SMITHS COIN METER - TYPE OF COIN ACTION NEW £1.00 COIN

TYPE "Y" COIN ACTION

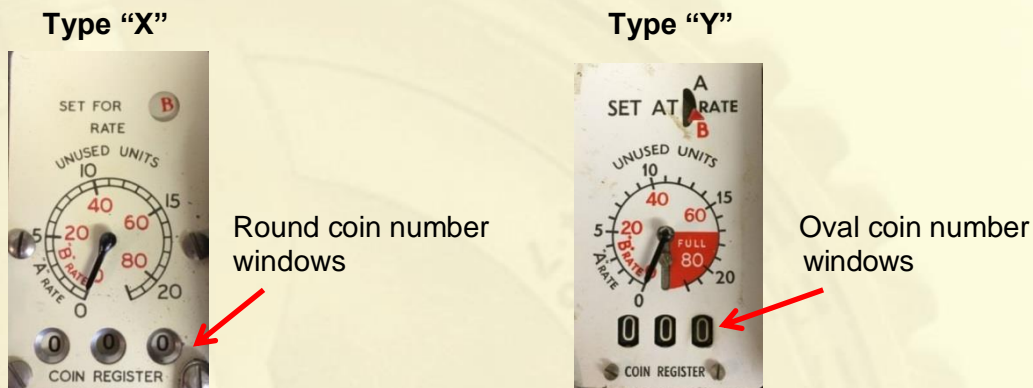
This type of coin action has a large circular brass attachment where the butterfly handle attaches. All of this type of coin action will require a small amount of filing to the outer edge of the coin entry slot before the coin action will accept the new £1.00 coin.

The outer edge of the coin action requires a small amount of filing to accept the new £1.00 coin.
